24590-LAW-PCN-ENV-19-008

**Hanford Facility RCRA Permit Modification Notification Form**  
**Part III, Operating Unit 10**  
**Waste Treatment and Immobilization Plant**

Modification to the Hanford Site RCRA / WTP Dangerous Waste Permit consisting of updates to Piping and Instrumentation Diagrams for the LAW Melter Feed Process System (LFP), LAW Secondary Offgas / Vessel Vent Process System (LVP), and Radioactive Liquid Waste Disposal System (RLD). Updates performed are in accordance to WAC 173-303-830, Appendix I Modification citation number: A.3., equipment replacement or upgrading with functionality equivalent components (e.g., pipes, valves, pumps, conveyors, controls).

The purpose of this Class <sup>1</sup> modification is to provide Piping and Instrumentation Diagrams (P&IDs) for the LAW Melter Feed Process System (LFP), LAW Secondary Offgas/Vessel Vent Process System (LVP), and Radioactive Liquid Waste Disposal System (RLD) for incorporation into Appendix 9.2 of the WTP RCRA permit:

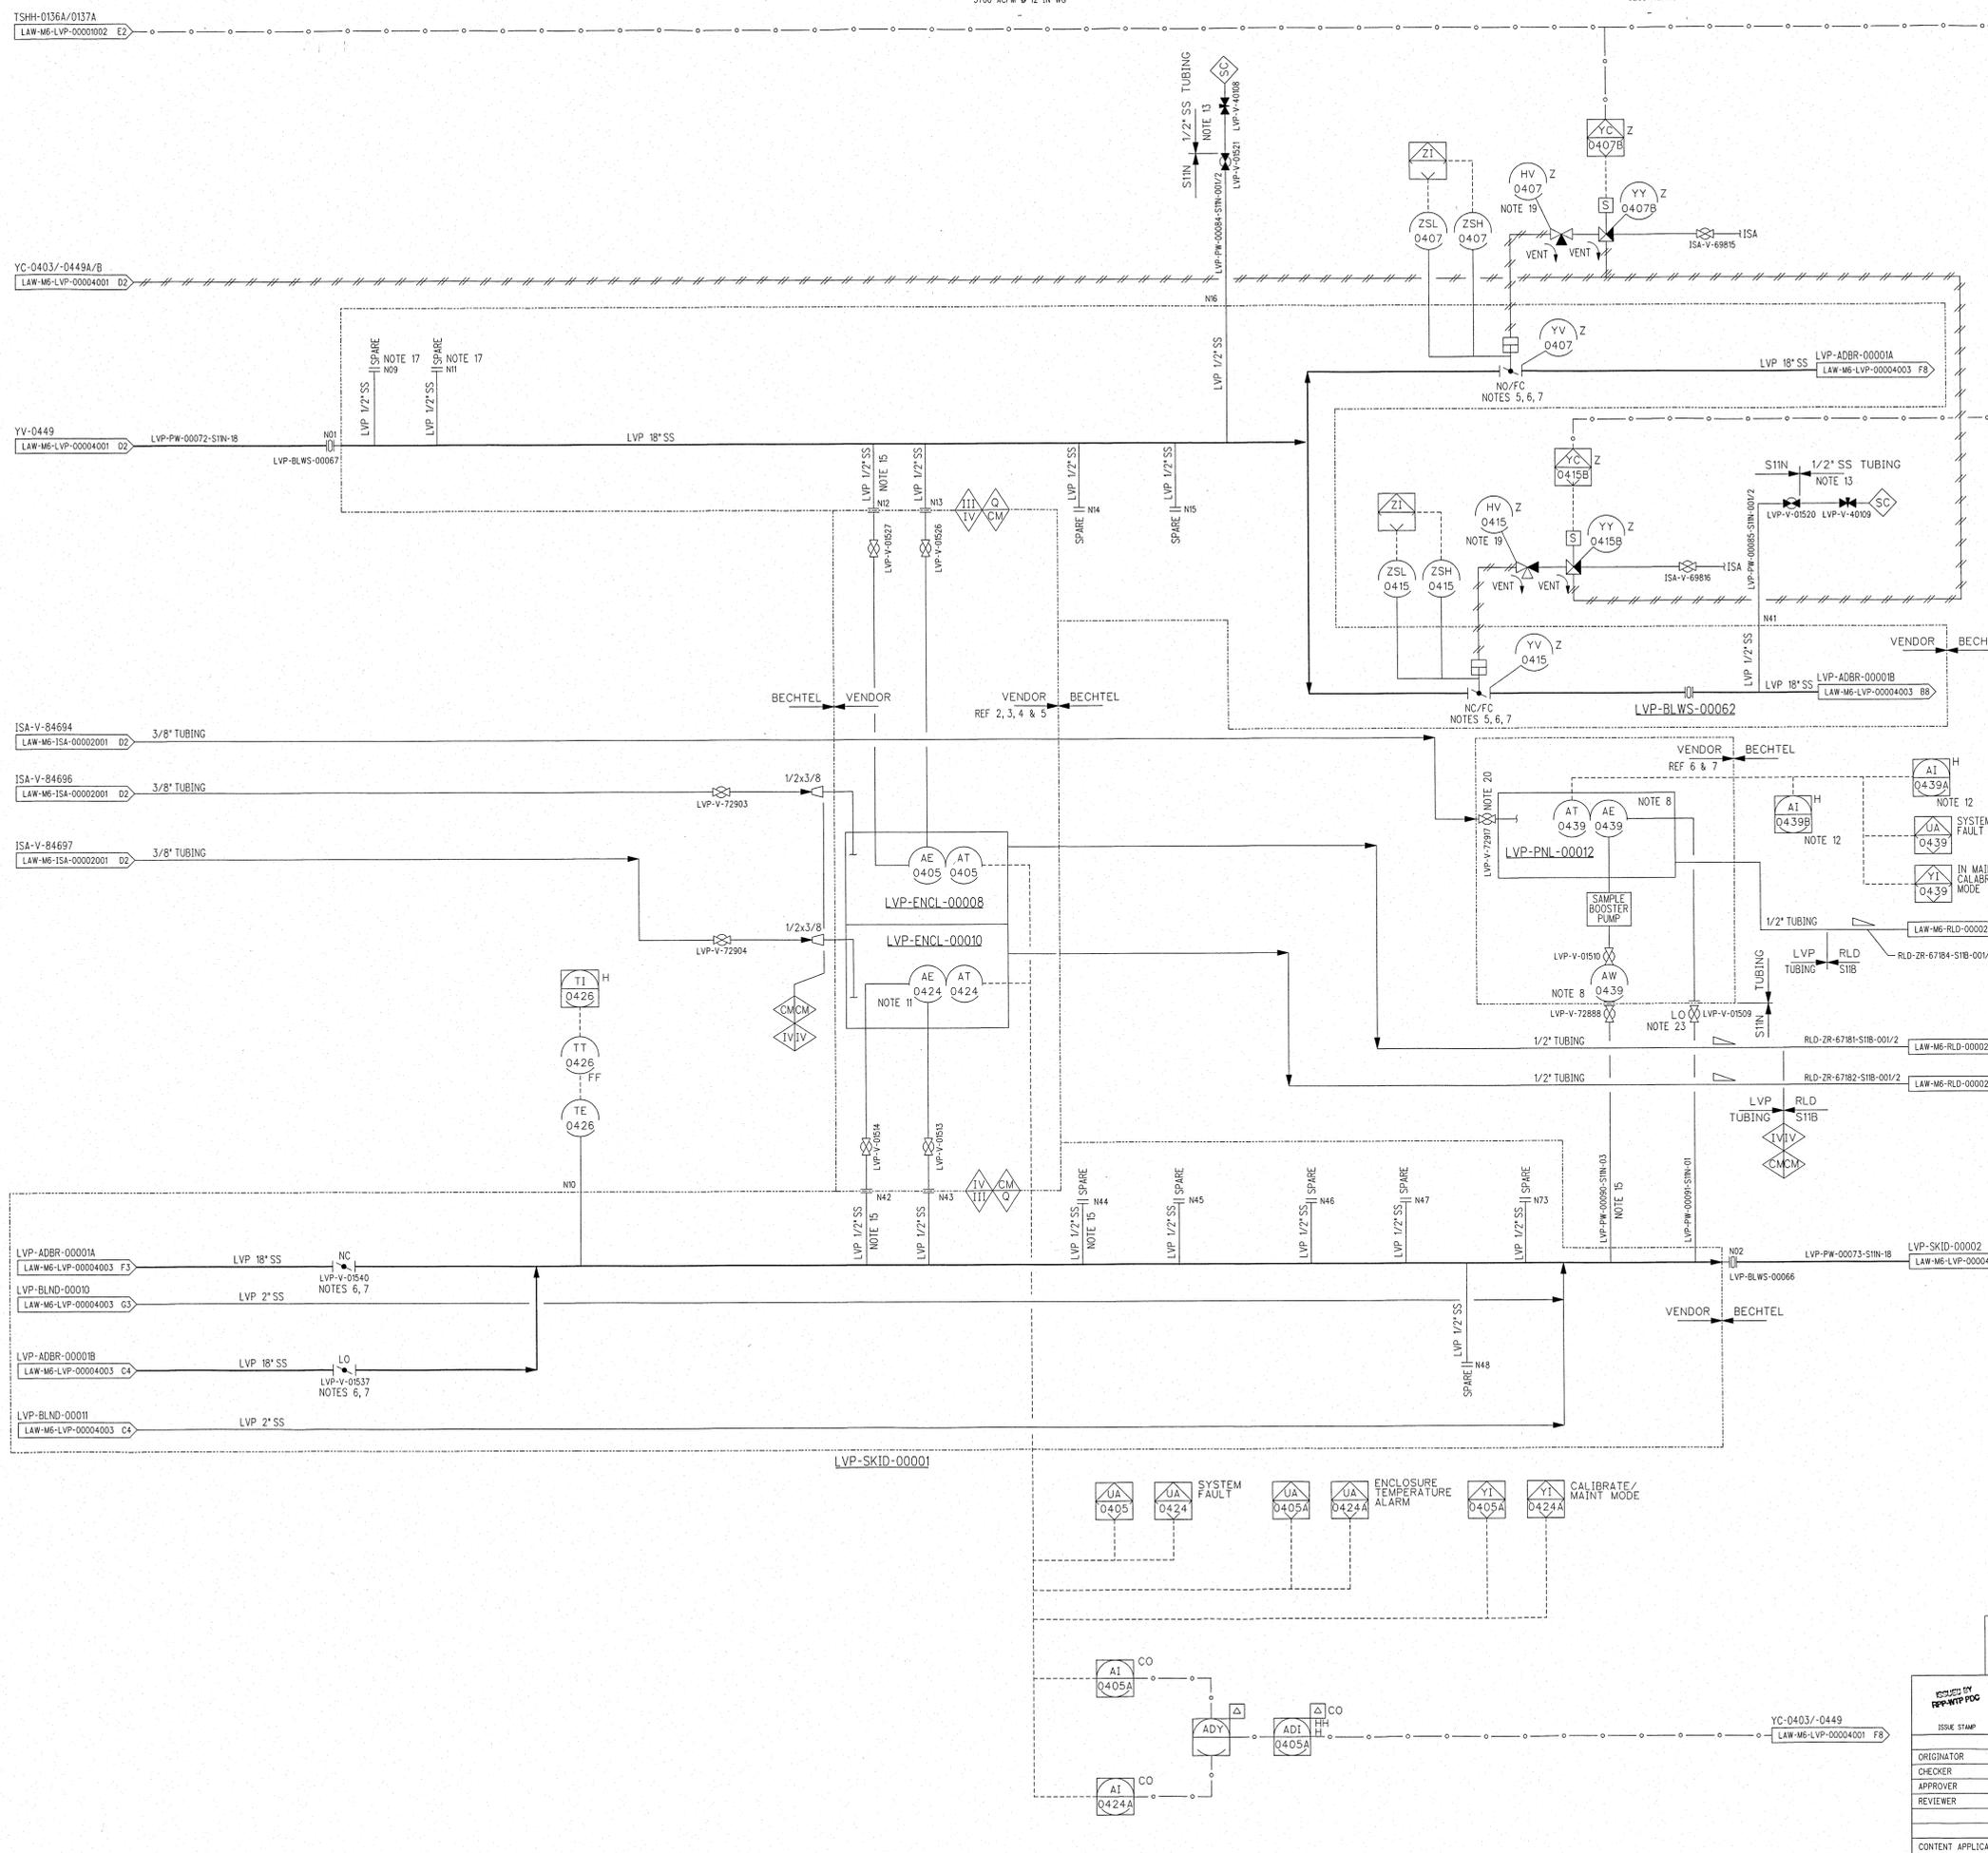
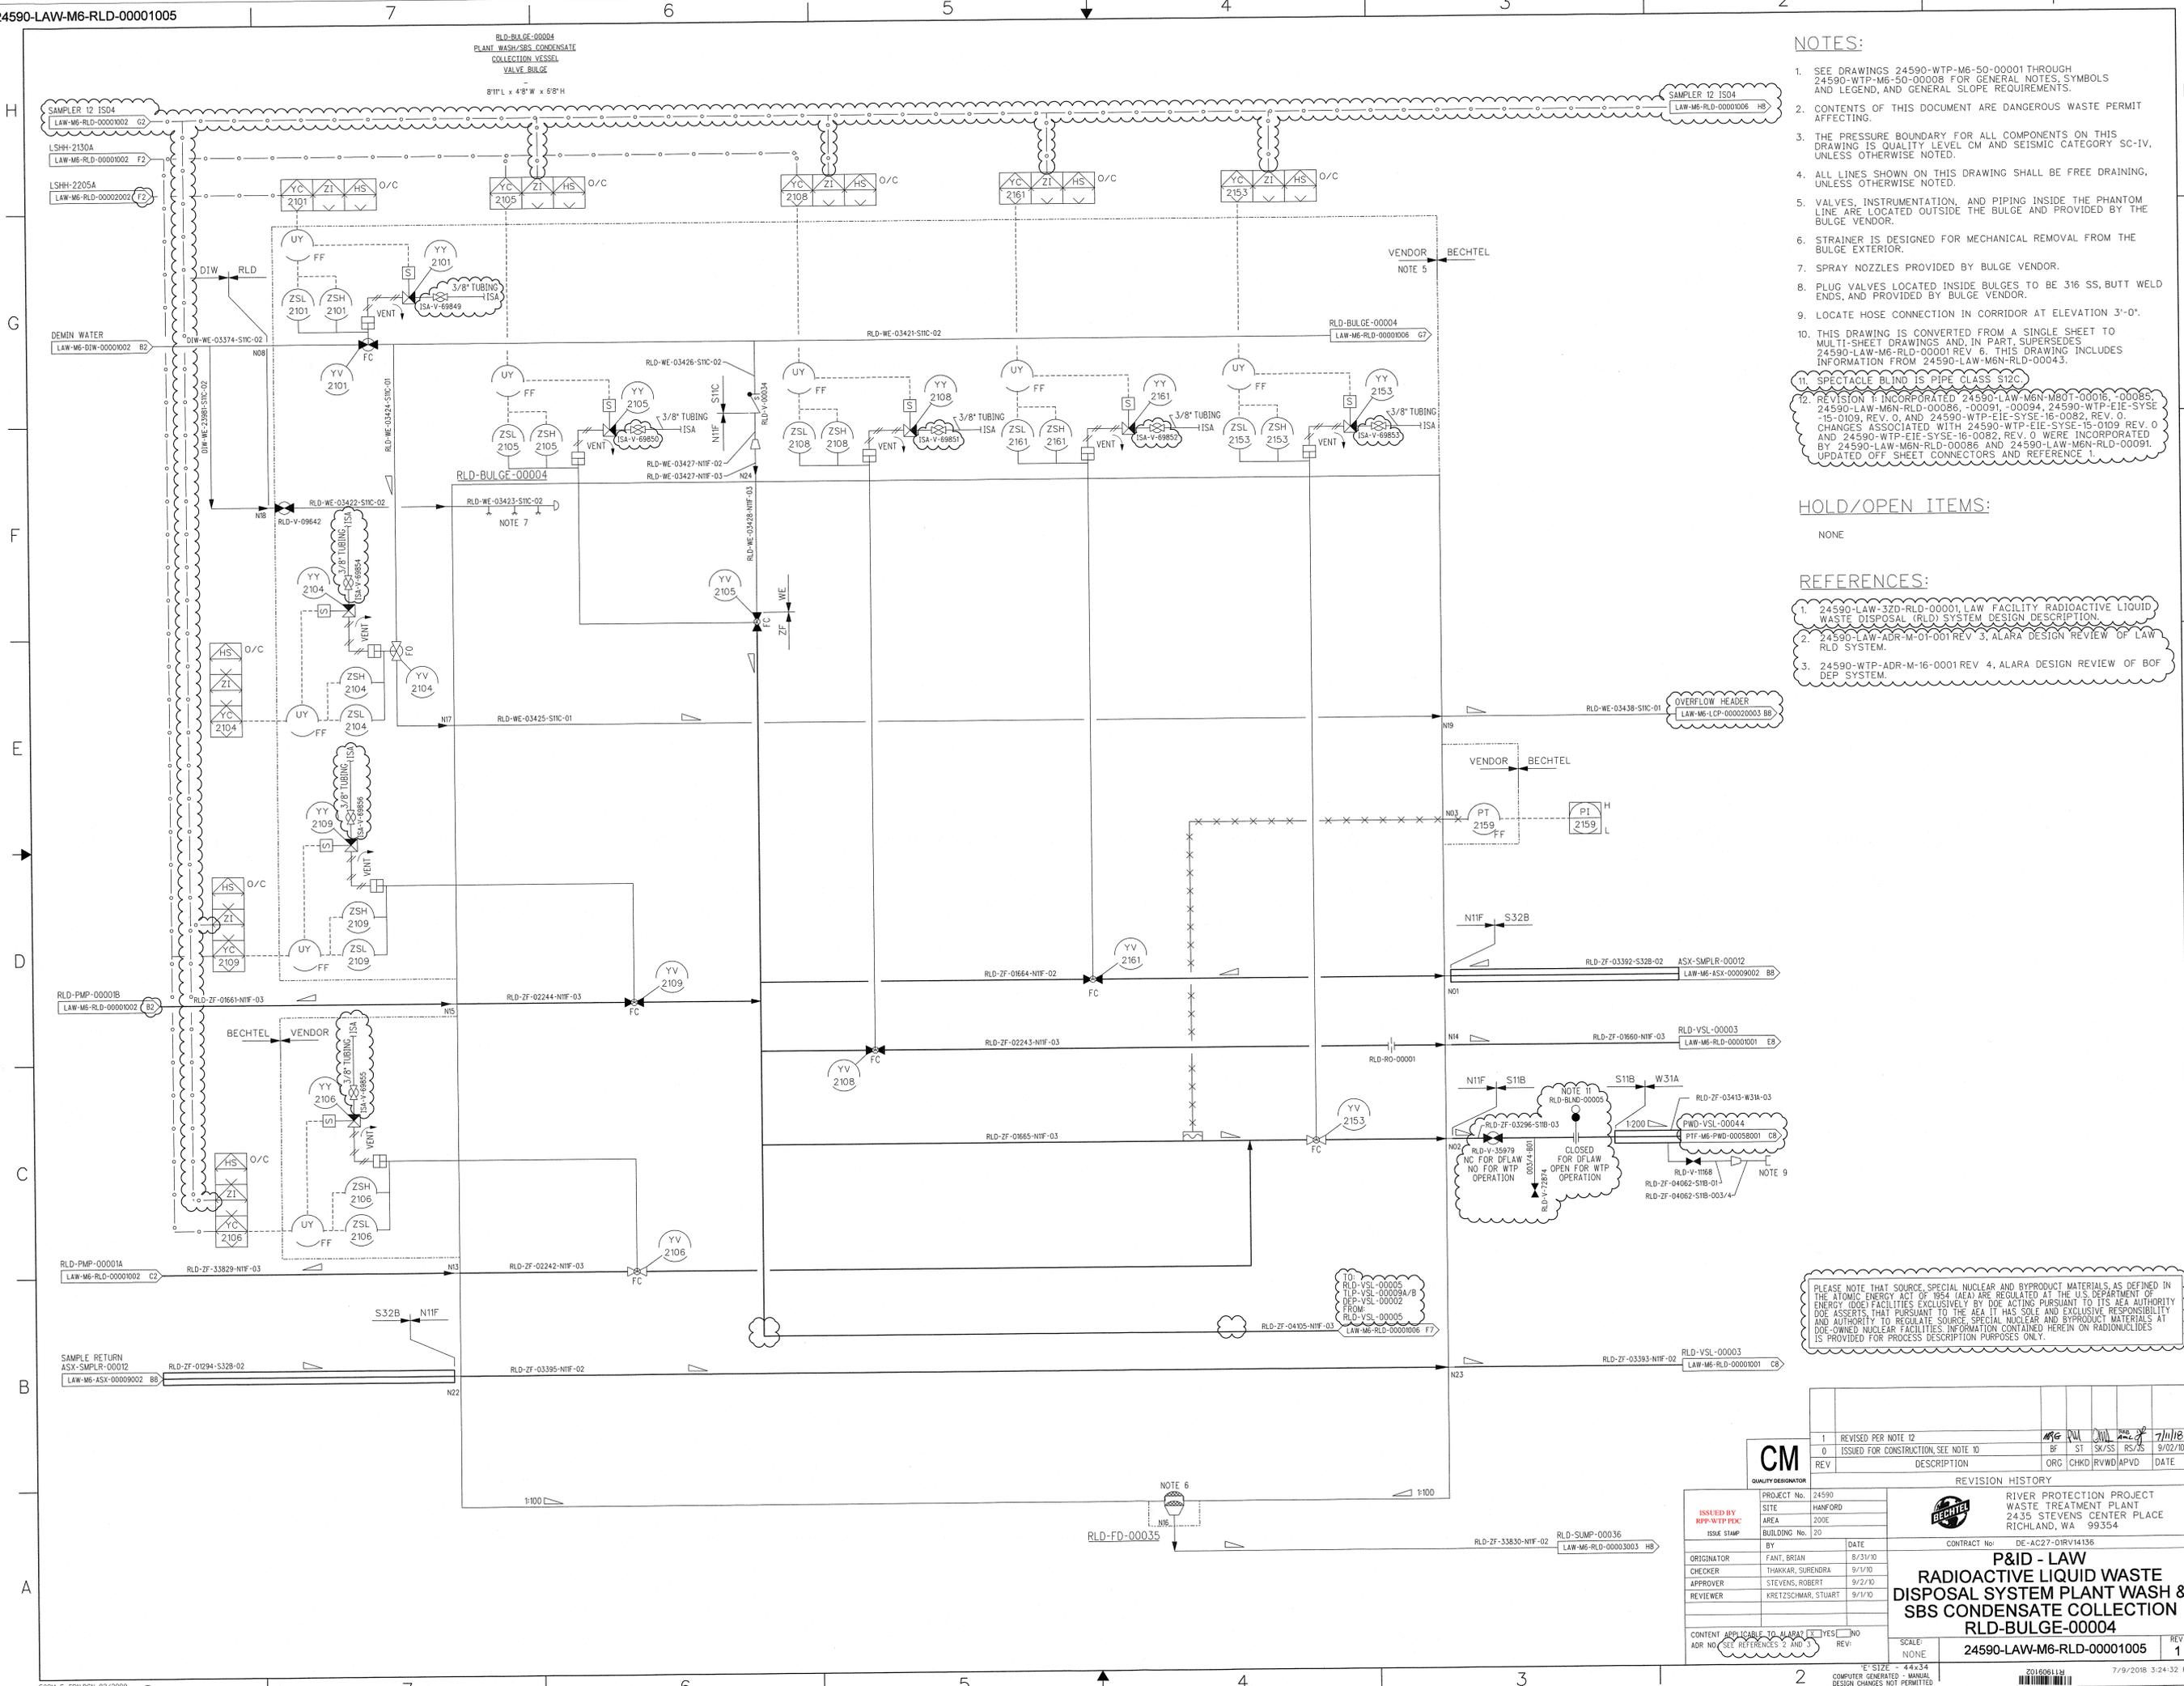
- b. Deletion to Note 11, instruments AE-0406 and -0425 are removed. The subject AEs were NO<sub>x</sub> monitors that were originally proposed (early in the project design) to be utilized as part of feed forward control for the ammonia dilution skid (associated with the Thermal Catalytic Oxidizer - TCO). These monitors added significant complexity to the ammonia control system. This complexity reduced the overall reliability of the ammonia control. In addition to the added complexity, it was determined that there was insufficient response time to effectively utilize a feedforward scheme (i.e., the offgas reached the TCO too quickly after passing these analyzers). When the sample and response times were factored in, a feedforward control

- f. Addition of Note 24, Revision 4, incorporated documentation and revisions.
  - g. Addition of Reference 2, 24590-QL-POA-JA03-00008-08-00007 drawing – TDLS co system tubing detail.

- h. Addition of Reference 3, 24590-QL-POA-JA03-00008-08-00008 drawing – TDLS co system master tag list.
  - i. Addition of Reference 4, 24590-QL-POA-JA03-00008-08-00001 drawing – TDLS co system cabinet layout.

- j. Addition of Reference 5, 24590-QL-POA-JA03-00008-08-00002 drawing – TDLS co system cabinet layout.
  - k. Addition of Reference 6, 24590-CD-POA-JA03-00007-07-00019 drawing – Analyzer LVP-AT-0439 LVP-PNL-00012 / sample system tubing schematic diagram.

- l. Addition of Reference 7, 24590-CD-POA-JA03-00007-07-00022 drawing – Analyzer LVP-AT-0439 LVP-PNL-00012 / analyzer enclosure general arrangement drawing (exterior).

- REVISION 4: MAJOR REVISION. NO REVISION CLOUDS REQUIRED. INCORPORATED 24590-LAW-M6N-LVP-00160/-00165, 24590-WTP-SDDR-J-18-00014, AND CCN 308167. INCORPORATED 24590-LAW-EIE-MS-14-0007 REV 0 WITH NO IMPACT.
